Agenda Date: February 10, 2022
Item Number: E5

Docket: PG-220008
Company Name: Cascade Natural Gas Corporation

Staff: Dennis Ritter, Pipeline Safety Engineer

Figure 1: Pipe-size breakdown of Phase I. 6" Along Leslie Rd. 12" along Columbia Park Trail and 8" after R-133 to the existing line tie-in.

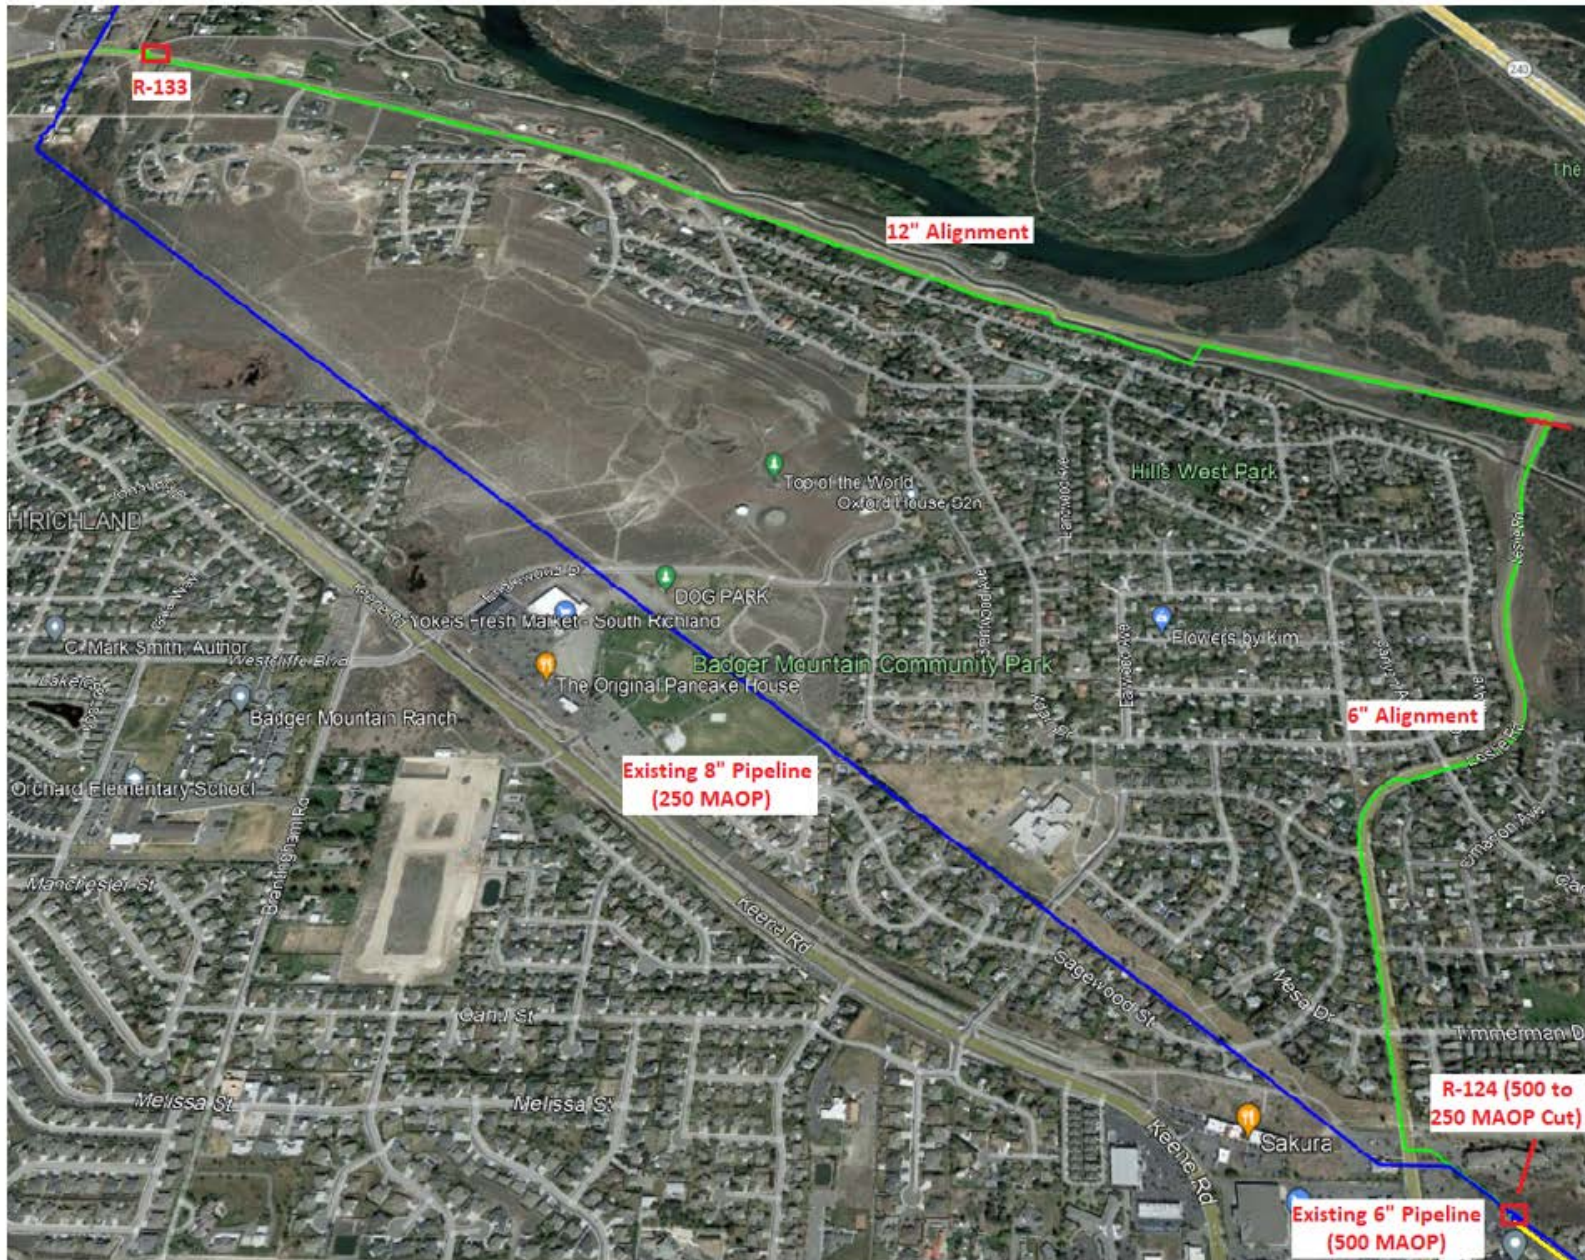
Cascade is proposing to construct and operate a new steel pipeline consisting of 12-inch, 8-inch and 6-inch diameter sections and a new regulator station, R-133 (Figure 1). The proposed alignment of this new line will be within 100 feet of 80 existing buildings in Richland, Washington not owned by Cascade (Table 1 and Figures 2-7). The MAOP of the proposed pipeline will be 500 psig. The proposed pipeline will operate concurrently with an existing 8-inch pipeline (Figure 1) that has a MAOP of 250 psig. The proposed pipeline will maintain core customer needs and have the ability to supply necessary capacities for future growth in Richland.

Staff reviewed the proposed proximity request and calculations. As the facility will be new, there are no existing records. Staff notes the following facts:

- (a) The proposed MAOP of the new pipeline (Phase I and II) will be 500 psig.
- (b) The project will use API 5L, X52 piping and ANSI 300 fittings which are appropriate for the proposed MAOP.

- (c) Class location for the proposed pipeline is Class 3.
- (d) The approximate distance from the pipeline to the existing structures ranges from 30 feet to 100 feet. All other buildings along the route are greater than 100 feet from the pipeline.

- (e) At the proposed MAOP of 500 psig, the maximum stress level of the pipeline would be 16.35 percent of the specified minimum yield strength (SMYS) for the 12-inch line, 11.38 percent for the 6-inch and 8.29 percent for the 8-inch section. Pipelines that operate under 20 percent of SMYS are considered low-stress lines and pose a lower risk than pipelines operating above 20 percent of SMYS.
